# **Groundwater Application Review Summary Form**

Application # G- <u>19455</u>
GW Reviewer <u>James Hootsmans</u> Date Review Completed: <u>12/18/2024</u>
Summary of GW Availability and Injury Review:
☐ Groundwater for the proposed use is either over appropriated, will not likely be available in the amounts requested without injury to prior water rights, OR will not likely be available within the capacity of the groundwater resource per Section B of the attached review form.
Summary of Potential for Substantial Interference Review:
$\square$ There is the potential for substantial interference per Section C of the attached review form.
Summary of Well Construction Assessment:
☐ The well does not appear to meet current well construction standards per Section D of the attached review form. Route through Well Construction and Compliance Section.
This is only a summary. Documentation is attached and should be read thoroughly to understand the

Application G-19455 Blue Line Farms Inc

## Water-Level Measurements in Nearby Wells

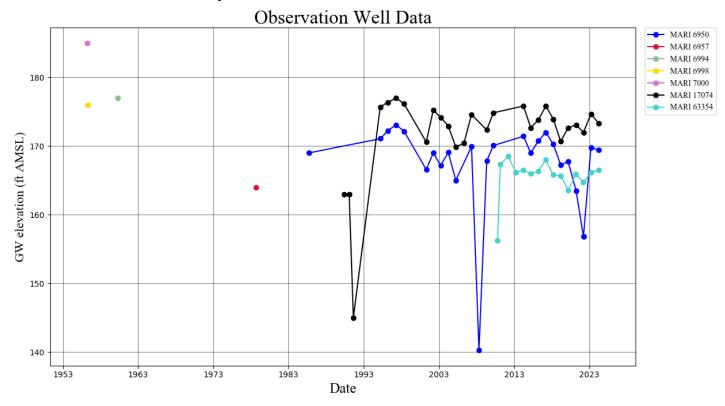
d.	<ul> <li>■ Well reconstruction is necessary to accomplish one or more of the above conditions. The problems that are likely to occur with this use and without reconstructing are cited below. Without reconstruction, I recommend withholding issuance of the permit until evidence of well reconstruction is filed with the Department and approved by the Groundwater Section.</li> <li>Describe injury —as related to water availability—that is likely to occur without well reconstruction (interference w/ senior water rights, not within the capacity of the resource, etc):</li> </ul>
В3.	will feet thic to b that	cundwater availability remarks: The application proposes three wells (MARI 6957, PROP 582 and PROP 583) that produce from the alluvial aquifer. The aquifer is overlain by about 60 feet of Willamette Silt (saturated to within 5-10 of land surface) at the proposed location and is comprised of an upper section of sand and gravel that is about 100 feet and a lower section of mostly silt and clay that is several hundred feet thick. Water-level trends in nearby wells appear e related to decadal climatic trends and show no obvious progressive declines (see Observation Well Data). This indicates the alluvial aquifer is not likely to be over appropriated in the area. However, because of the short period of record and ted overall data, water-level monitoring is recommended in the proposed wells.
